Service Bulletin No: 57-006

Modification No: EC-16-0061

**WINGS - AILERONS  
INSPECTION OF THE AILERON MASS-BALANCE COUNTERWEIGHT ATTACHMENT****1. Planning Information****A. Effectivity**

Aileron Balance-Weight Attachment - Inspection/Check  
Figure 1

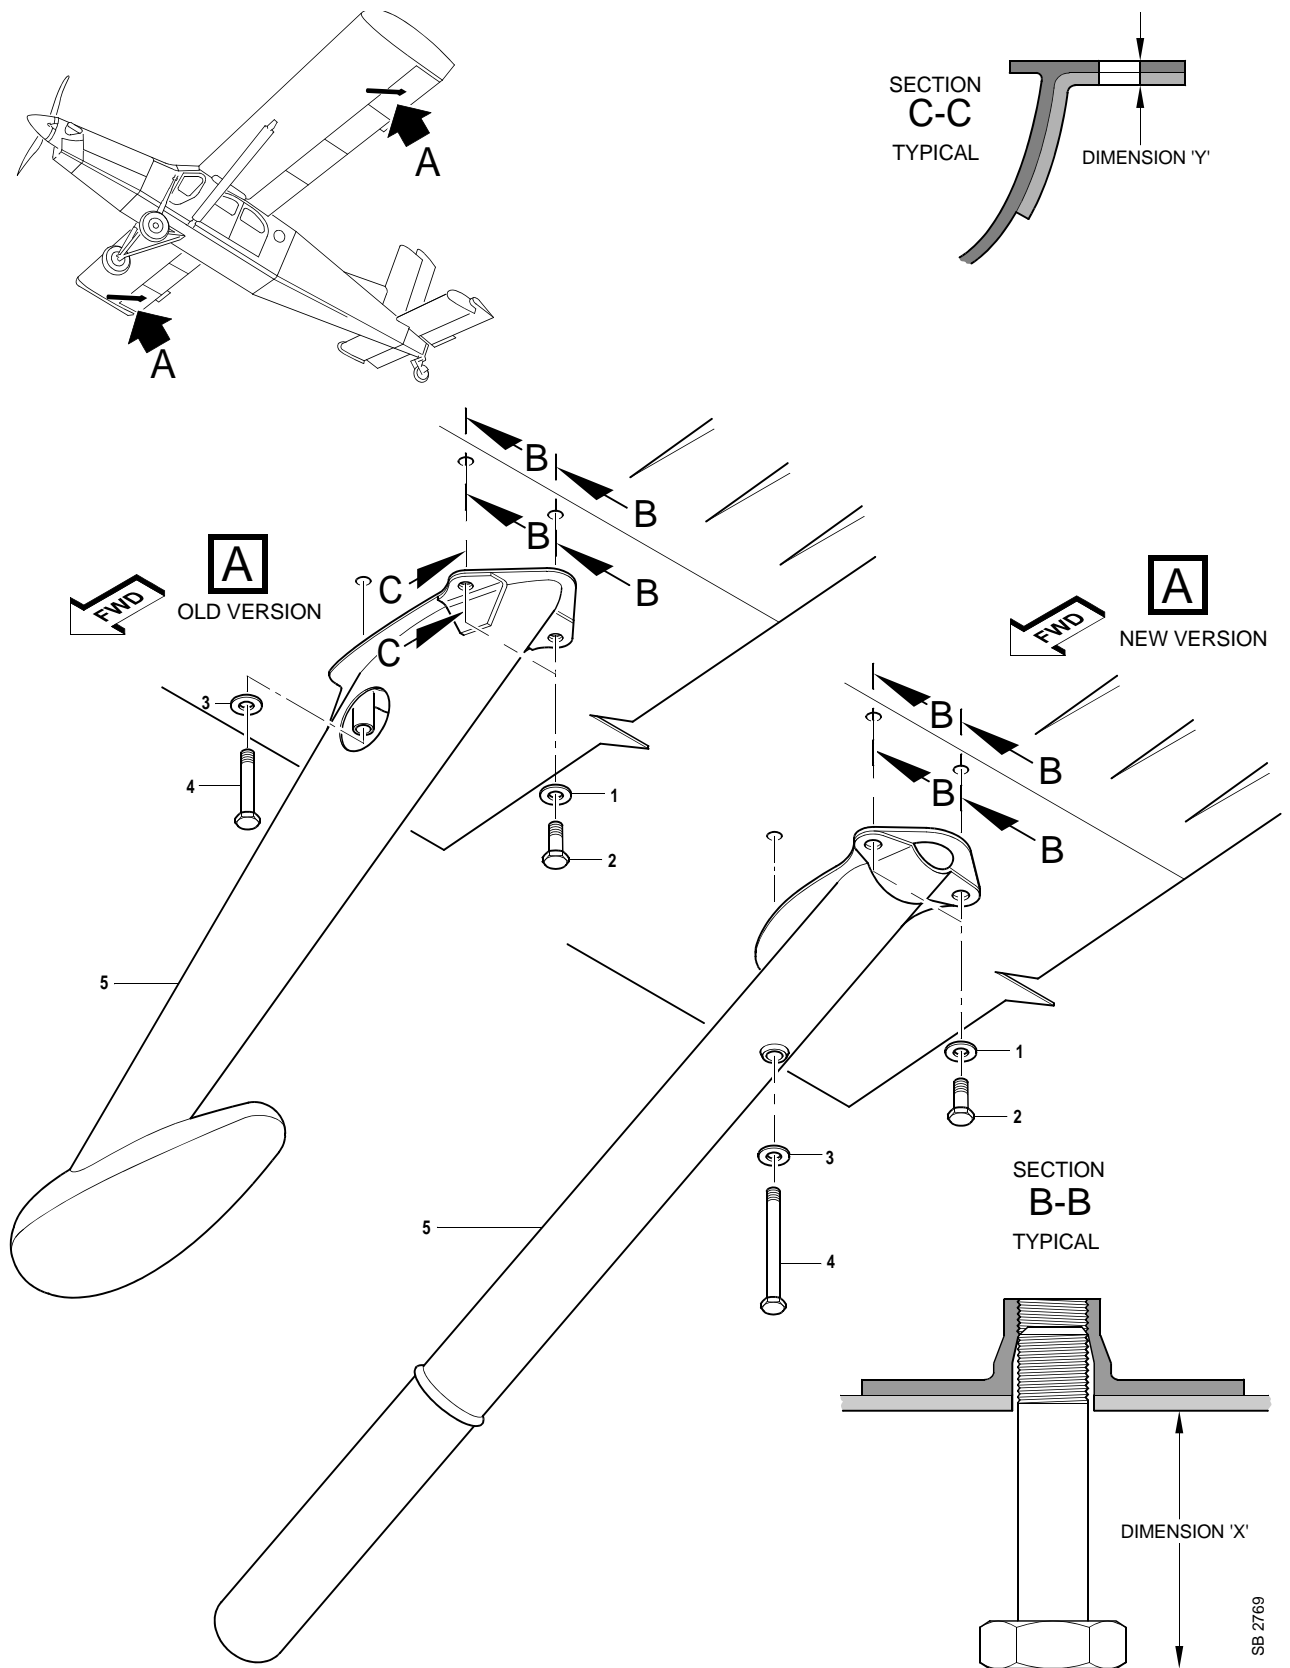
There are old and new versions of counterweight and it is possible that some bolts that attach the counterweight to the aileron can have inadequate thread engagement.

Several combinations of anchor nuts, bolts and washers can be installed at the aft attachment points. Also, the thickness of the mounting flange on the old version counterweight can vary. Some combinations of counterweight and attaching parts can result in reduced thread engagement.

- (a) Use absorbent paper (Material No. P02-031) made moist with solvent (Material No. P01-008) to clean the surface of the aileron around the two aft attachment holes.
- (b) Put a new bolt (2) (P/N 932.53.47.009) into one of the two aft attachment holes and turn it until the threads engage in the anchor nut.
- (c) Turn the bolt (2) back until it is released from the anchor nut and hold it in this position.
- (d) To determine the type of anchor nut installed, measure the Dimension 'X' as shown on Figure 1, Section B - B.

- 1 If necessary, remove any thick paint from the flange to permit an accurate measurement.
- 2 Measure the Dimension 'Y', as shown on Figure 1, Section C - C, at the flat surface where the washer is installed.

Do an inspection/check to determine the type of anchor nuts installed at the aft attachment points and, if necessary, the thickness of the mounting flange, then install the counterweight with new bolts and the correct washers.

- (a) For each of the two aft attachment positions, refer to Table 1 and determine the correct type and quantity of washers to be installed.

- (b) Support the counterweight (5) in the installed position.
- (c) Install the removed bolt (4) and washer (3).
- (d) At each of the two aft attachment positions, install a new bolt (2) (P/N 932.53.47.009) with the correct type and quantity of washers (1).
- (e) Torque tighten the bolts (2) and (4) to between 3,9 and 4,5 Nm (35 and 40 lbf. in.).
- (4) Do the procedures again for the right outboard aileron.
